RE: DARLING SQUARE NORTH PLOT – MEMORANDUM ON PROPOSED DESIGNS FOR PERFORATIONS WITHIN THE RISER FACES AT THE EXTERNAL STAIRWAY v3

The following statement pertains to the external stairway that runs from ground level to level 1 at the North Plot building at Darling Square in Haymarket NSW.

Figure 1: Perforation sightline diagrams
Source: Lendlease Design

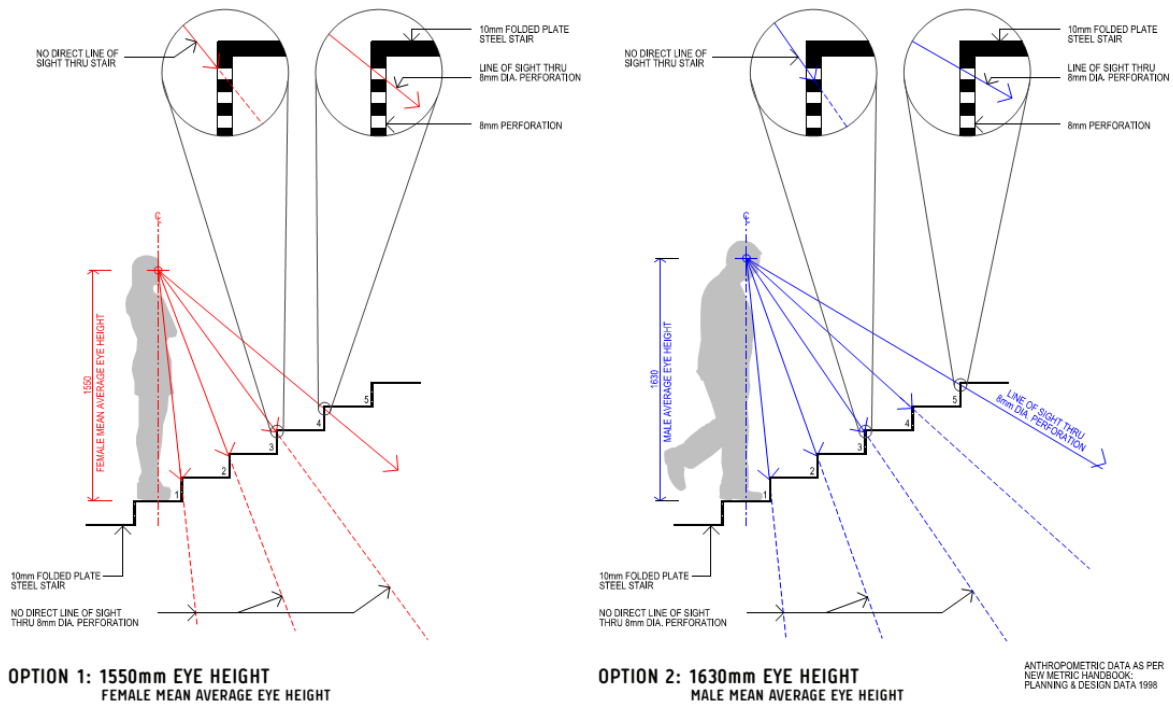
For the external stairway at the North Plot building, three options have been tested for the provision of perforations at the faces of the stair risers. Based on the supplied design studies, all three options would be reasonable solutions to allow a user with a vision impairment to identify the next few treads of the stairway when he or she is ascending the stairway. This is because, from the point of view of such a user, the visual transparency through the next few riser faces would be kept to a minimum due to the size of the pattern when viewed from above. This is illustrated in Figure 1 below.

MGAC have reviewed the visual studies provided of each option, and confirm that there would be no direct line of sight through the perforations for a user when he or she is physically on the stairway itself. This would have the effect of minimising the ambiguity for such users as to the location of the next treads, and would be supportable as a Performance Solution.
